Report: *Meadowbank Dike Review Board Reports #14*

September 23rd, 2013

**Report No 14
Meadowbank Mine Dike Review Board
Meeting September 9-11, 2013**

Photo #4 Site of seepage observations at waste rock pile. Pond RP-2

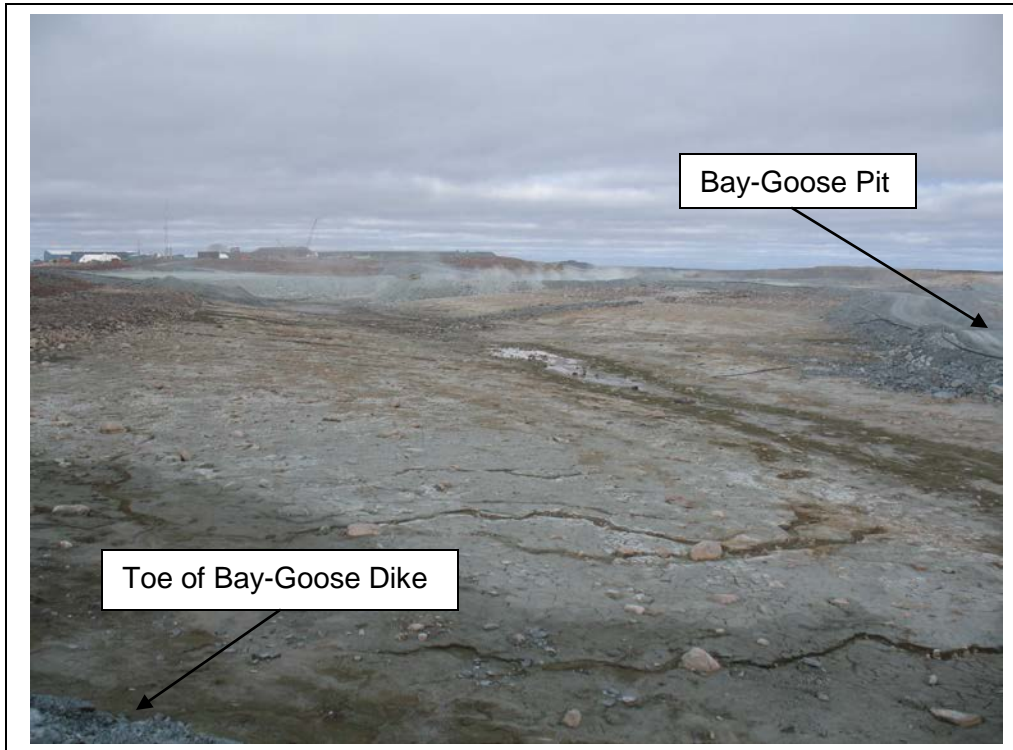
The Board was informed of the situation regarding seepage from the TSF through the Rock Storage Facility (RSF). A good summary of the sequence of observations and of the water chemistry was provided. The diagnostic studies are ongoing. The Board accepts the view that there has been a tailings water communication which, with other contaminants from the rock pile, has reached the perimeter of pond NP-2 situated to the north of the RSF. In the pre-mine natural conditions, pond RP-2 drained to Second Portage Lake through what is now the TSF. The outlet to the lake is at around elevation 141 m and with the TSF pond now at elevation 143 m, a hydraulic gradient in the reverse direction has now been created. As part of the plan

to minimize run-off towards the TSF, a series of ditches have been excavated from the high end of the catchment area to the north, leading water away from the TSF to the west and to the east of the latter. One such series of ditches passes through RP-2 and connects with ponds which ultimately drain to the Second Portage Lake at a point to the south of the Portage Pit. These works thus have the consequence of directing any seepage water that enters RP-2 to the outside of the Lease Boundary. This potential flow path was identified and mentioned in a Technical Memorandum from GAL dated March 24, 2011. It was hypothesized that the tailings beach and long term ingress of freezing would minimize the amount of water reporting to the RSF. The current situation has arisen in part due to the lack of a beach on the eastern shore of the TSF as shown in photograph #3.

The Board does not agree that this is an adequate approach and wishes to draw attention to the possibility of tailings piping through the coarse run-of-mine rock that comprises both the Rockfill Roads RF-1 and RF-2, as well as the RSF. Such a loss of tailings could release water from the decant pond towards RP-2 and overwhelm a seepage collection facility. The Board recommends proper evaluation made of cut-off alternatives, one of which could be a freeze wall created by a row of passive thermosyphons which would function very efficiently in a location such as Meadowbank.

Photo #7 Crest of Bay-Goose Dike, upstream shell

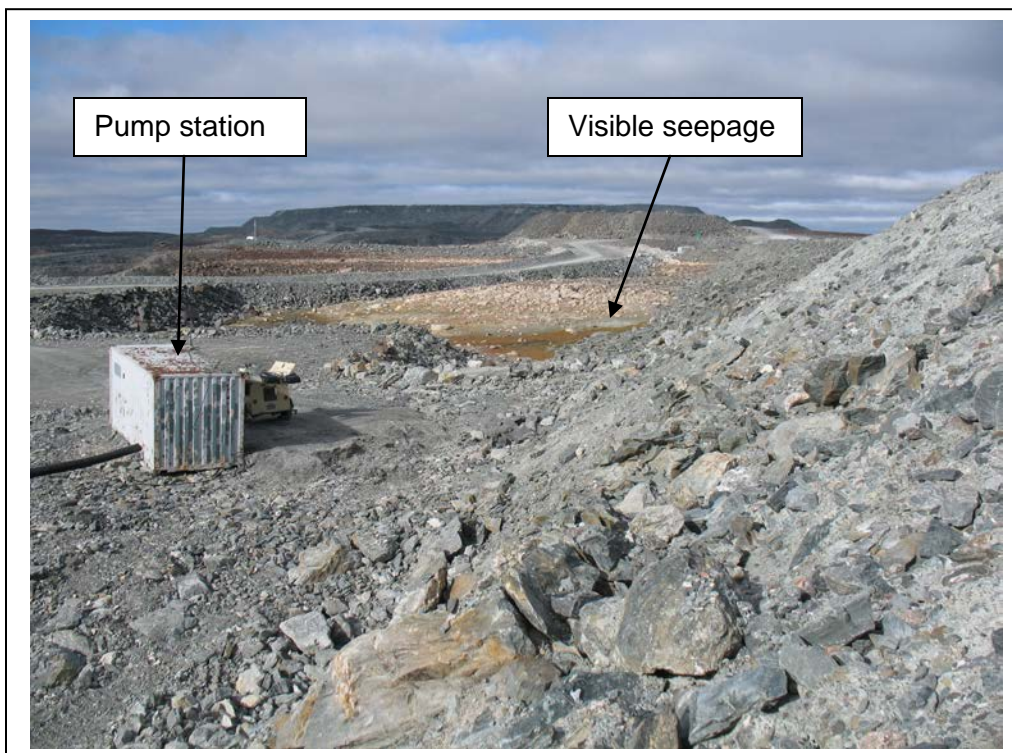
While it is clear that other maintenance items are being addressed, the results may leave something to be desired. During the site tour, the Board observed the capping that had been placed on the Bay-Goose Dike during the preceding winter. This rockfill capping enhances thermal protection of the core but as it was placed during winter, ice and snow were incorporated in the fill. Moreover, no compaction was carried out. As a result, the surface is irregular and several cracks were noted (photos #6 and #7). This hampers the identification of any settlement or cracking related to the performance of the body of the dike. Compaction and grading of the surface is recommended.
